SUBJECT: STRUCTURAL INSPECTIONS AND SIGN-OFF FOR REPAIR / RE-LEVEL TO EXISTING RESIDENTIAL BUILDING AT 38 VIVIAN STREET, BURWOOD, CHRISTCHURCH 8083.

STRUCTURAL REPAIR ASSESSMENT

SITE INSPECTION REPORT

2 PARTIAL FOUNDATION REPLACEMENT DETAIL
SCALE A1 1:10 / A3 1:20

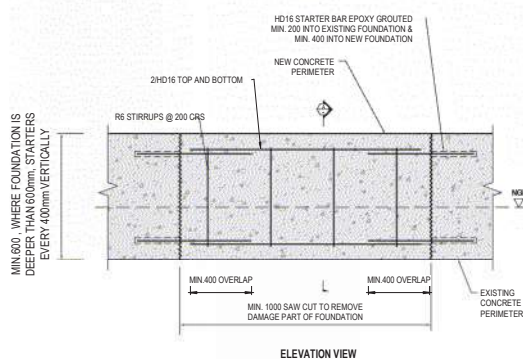
8) Foundation replacement, existing bar to retain, additional bar as per detail. **SEND PHOTOS TO ENGINEER FOR APPROVAL.**

SITE VISIT ON 27-05-2025. OK.

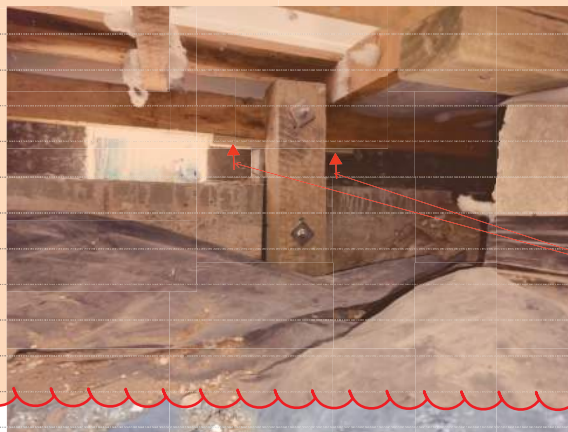
8. Missing bearer to foundation connection was observed for the packer along the chimney base (on both end) below Bedroom 2. **RECTIFY AND SEND PHOTO.**

2/S/S SHEET BRACE STRAP WITH 8G TEK SCREW INTO PILE AND BEARER
